**MASTER PLAN AND ZONING COMMITTEE**  
**City of Novi Planning Commission**  
**March 28, 2017 at 6:00 p.m.**  
**Novi Civic Center – Mayor’s Conference Room**  
**45175 W. Ten Mile, Novi, MI 48375**  
**(248) 347-0475**  
**AGENDA**

**TO:** MASTER PLAN AND ZONING COMMITTEE  
**FROM:** BARBARA MCBETH, AICP, CITY PLANNER  
**SUBJECT:** CONSIDERATION OF PRO CONCEPT PLAN FOR PRINCETON PARK  
**DATE:** MARCH 27, 2017

Princeton Park

JSP17-10 with Rezoning 18.717

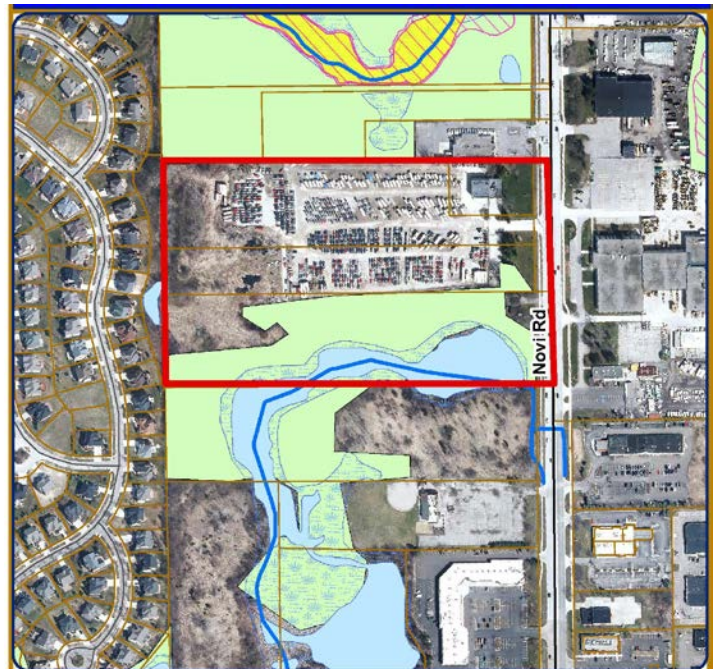
**Non-Motorized Improvements:** City of Novi Non-motorized plan planned for an off-road neighborhood connector to the north of the property through the City property connecting the sidewalks along Novi road to the existing single family subdivision on the west of the subject property. The applicant indicated that they would work with the City to provide this connector. Additional information is requested as listed in the Engineering review as how this can be achieved.

Figure 1. City of Novi Regulated Wetland & Woodland Map (approximate project area is highlighted in red). Regulated Woodland areas are shown in green and regulated Wetland areas are shown in blue).

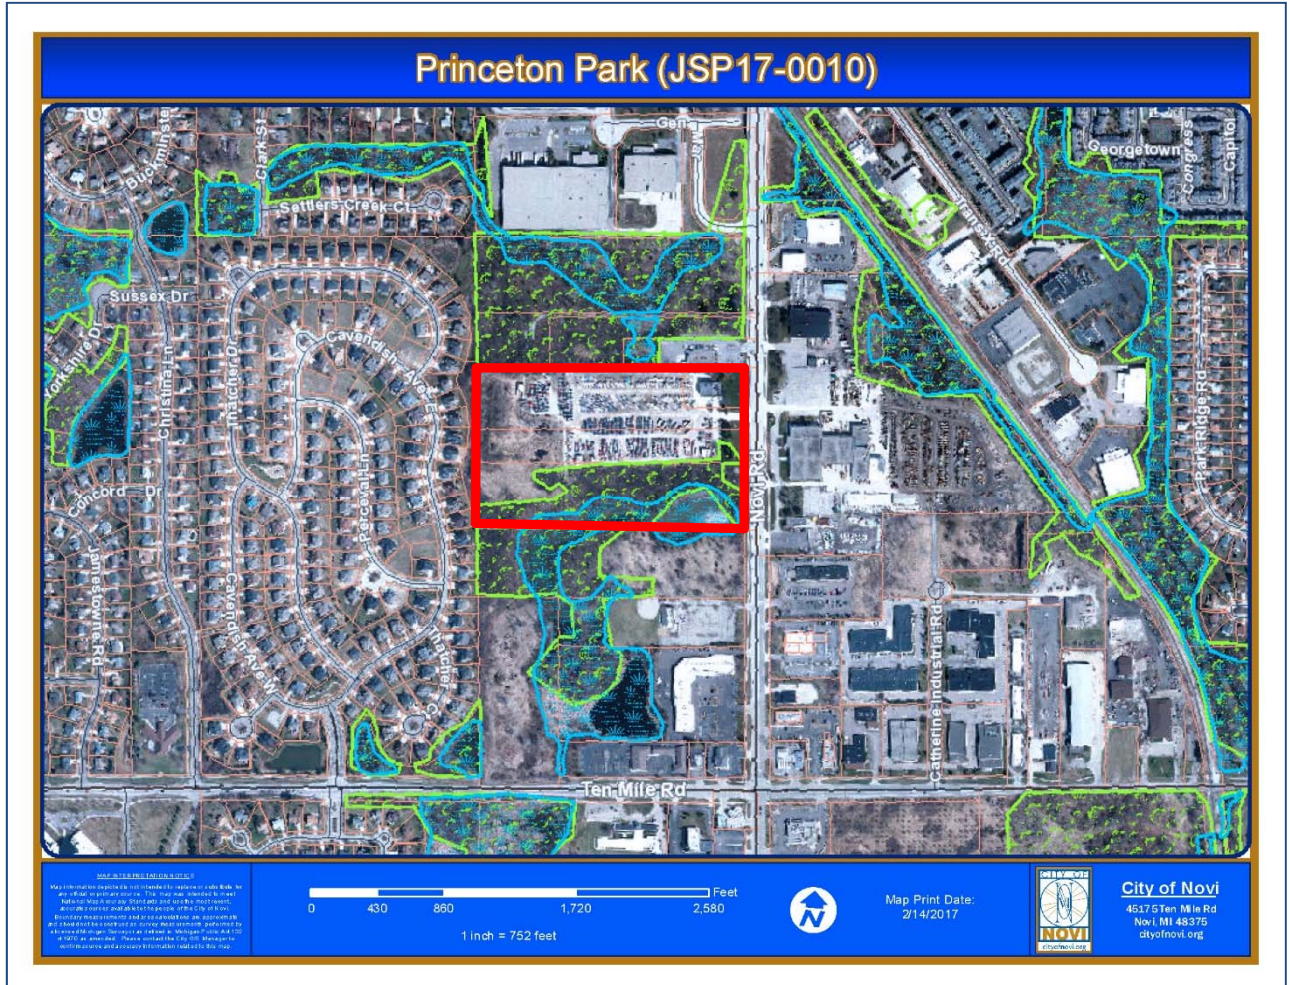
Based on our review of the Plan, Novi aerial photos, Novi GIS, the City of Novi Official Wetlands and Woodlands Maps (see Figure 1, attached) it appears as if this proposed project site contains City-regulated wetlands and woodlands. The City's wetland and woodland map shows that the overall property contains wetlands to the south. However, a review of aerial photos of the site and the proposed site plan, the site contains three (3) areas of wetland (Wetlands #1, #2, and #3), along both the southern and western portion of the site.

As noted, three (3) areas of wetland exist on this parcel (Wetland #1, #2, and #3). The proposed site development appears to be partly designed around the existing on-site wetland and 25-foot wetland setback areas. The *Layout Plan* (Sheet 05) indicates that the proposed development will impact Wetland #3 and the storm water outlet is currently planned to be directed to the 25-foot setback of Wetland #1, in the southeast portion of the site. The following table summarizes the existing wetlands and the proposed wetland impacts as shown on the Plan:

Figure 1. City of Novi Regulated Wetland & Woodland Map (approximate project area is highlighted in red). Regulated Woodland areas are shown in green and regulated Wetland areas are shown in blue).

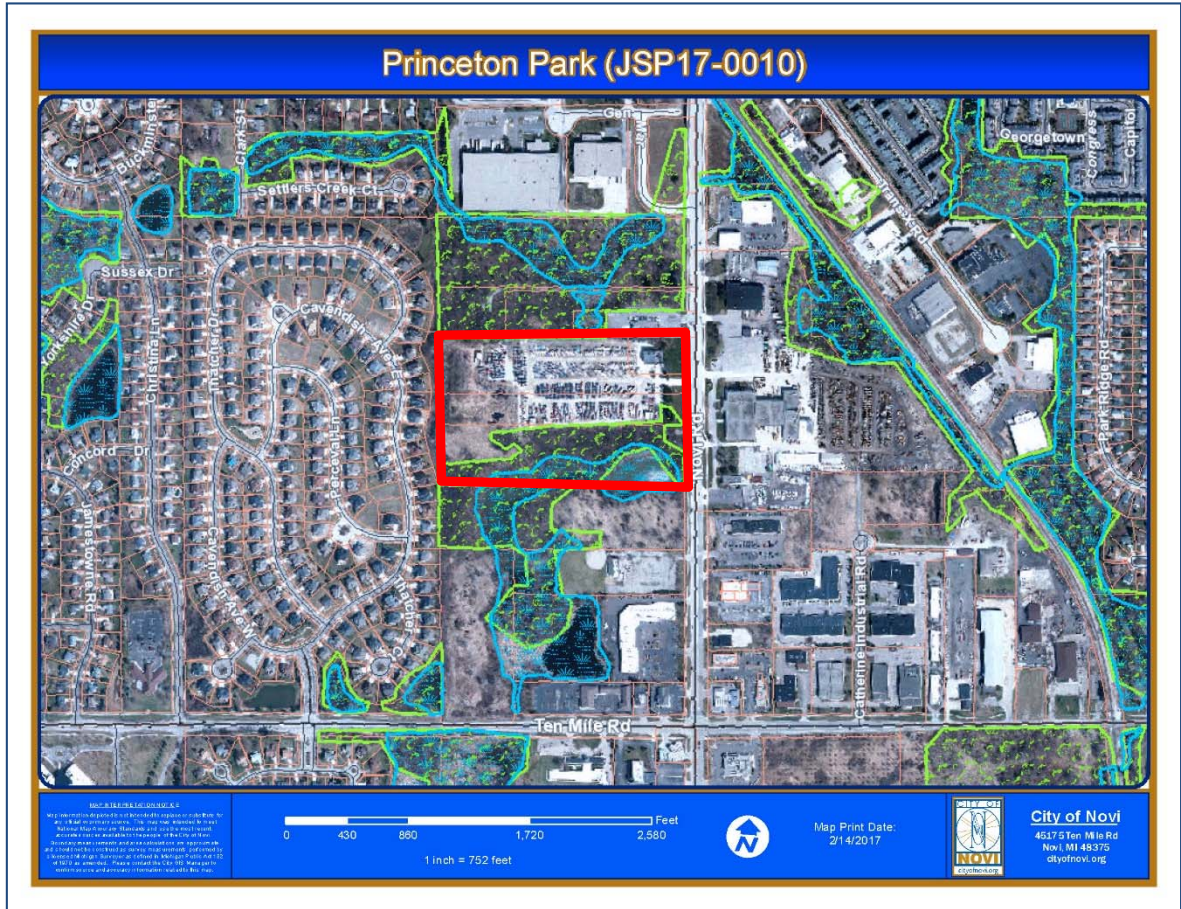
ECT completed an on-site woodland evaluation on Tuesday, February 21, 2017. As noted above, the site does contain area designated as City of Novi Regulated Woodland. A significant portion of the proposed limits of disturbance for the project is located outside of the areas mapped as City Regulated woodland (see Figure 1). The

majority of the Regulated Woodland area is located on the southern portion of the project site (see Figure 1). Tree survey information has been provided on the *Tree List* plan (Sheet 03). This sheet includes a tree list that indicates the proposed woodland impacts and required Woodland Replacement tree credits for these removals. The Plan indicates that a total of 328 trees have been surveyed for the project. Of the trees surveyed, 262 trees are located within the area designated as Regulated Woodland (80% of the surveyed trees are located within the regulated woodland area). Fifty percent (50%) of the surveyed trees are comprised of the following tree species:

FIGURE 1 – Proposed Neighborhood Connector Pathway  
 (Image Referenced From City Of Novi Non-Motorized Master Plan 2011)

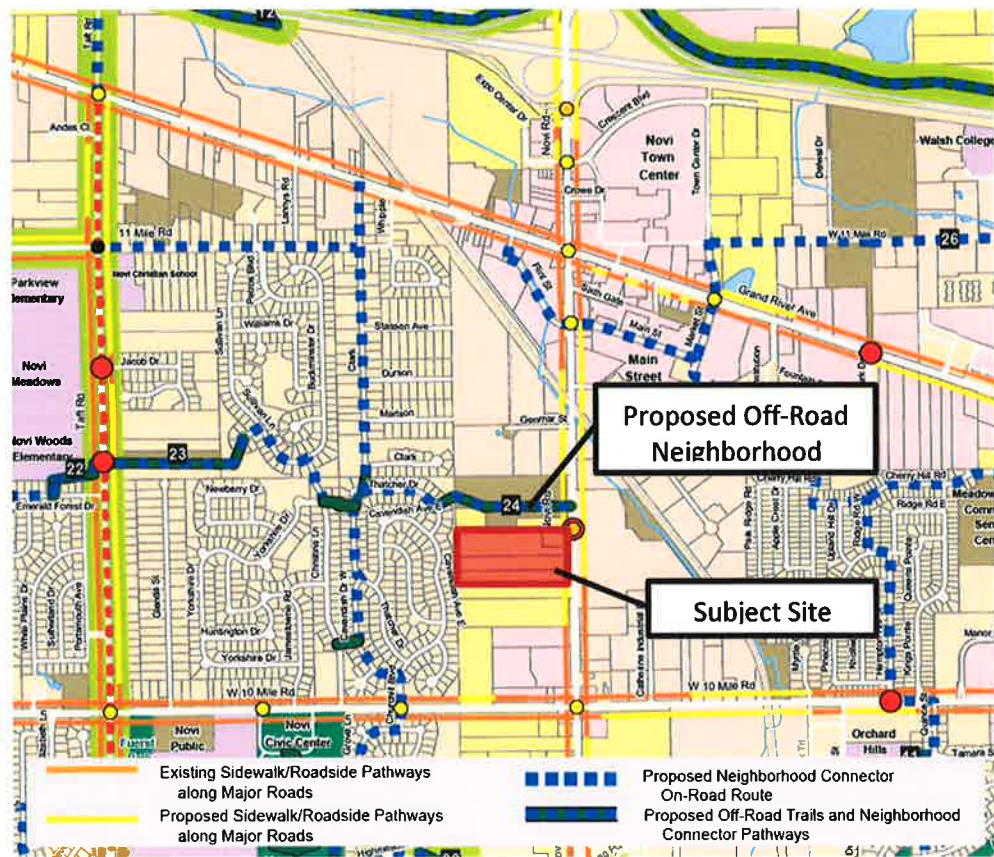
- **Neighborhood Connector:** The developer is proposing to coordinate and work with the City to provide a large portion of a key neighborhood pedestrian connection for the development and the adjacent developments out to Novi Road. This connector is part the City’s non-motorized transportation Master Plan.
